June 28, 2010

RE: Request for Partial Amendment to Permit for Central Maine Power Company's (CMP) Maine Power Reliability Program (MPRP)

**MAINE POWER RELIABILITY PROGRAM**  
EXISTING AND PROPOSED R.O.W.  
ALTERNATIVE N5 FOR N-1-1 ANALYSIS

SHEET N5-6-1

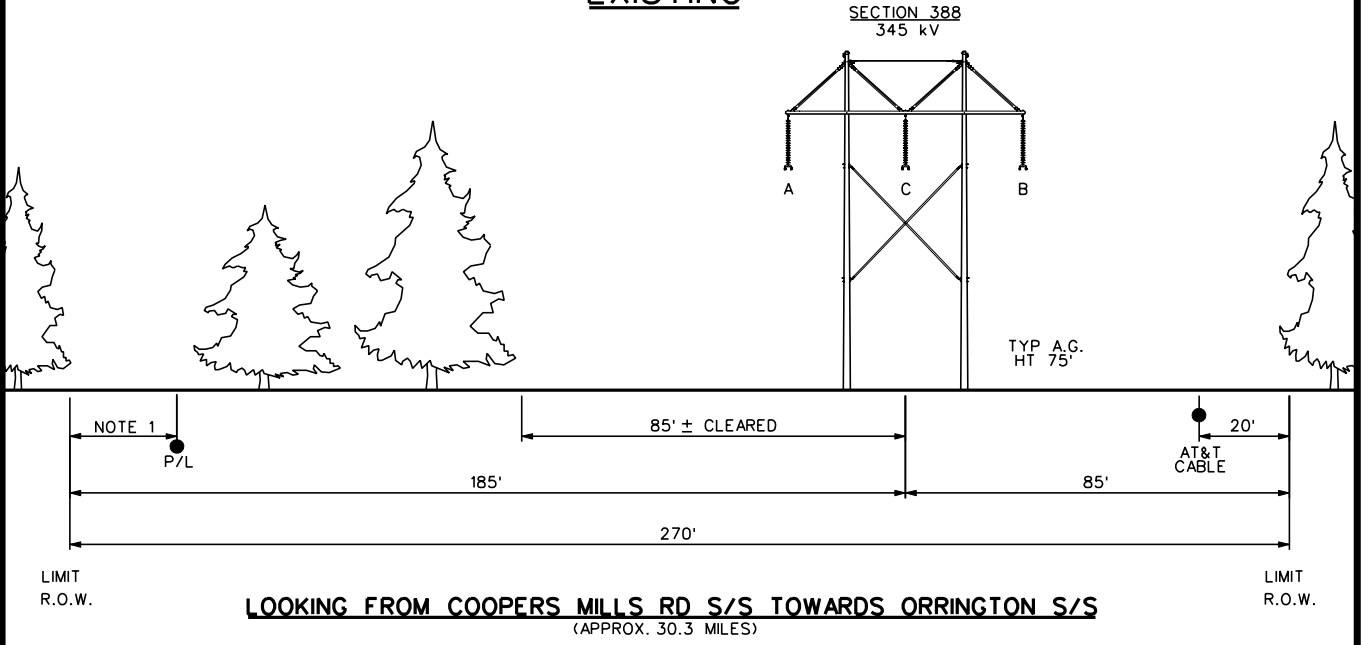
ISO New England, after its review of the MPRP, specified that the Section 254 structures be redesigned to use bundled conductors. As currently permitted, the Section 254 transmission line

is carried on H-frame structures with a typical height of 75 feet. As redesigned, Section 254 will be carried on H-frame structures with a typical height of 55 feet. The smaller structures will be centered 10 feet further toward the middle of the right-of-way than the structures in the previously approved design. Because the new structures are shorter than the original ones, the spans are not as long, requiring more structures overall. In Windsor, there will be three more structures for Section 254 with the proposed design than with the approved design. However, there are no more structures within the shoreland zone with this proposed design; the impacts to shoreland areas will be the same. Please see the enclosed cross sections and maps 6-1 through 6-3 for a visual depiction of the redesigned structures and their locations. The green dots and squares on the maps show the *permitted* locations for structures; the black dots and squares show the locations with the current, *proposed* design. The cross sections depict the smaller structures.
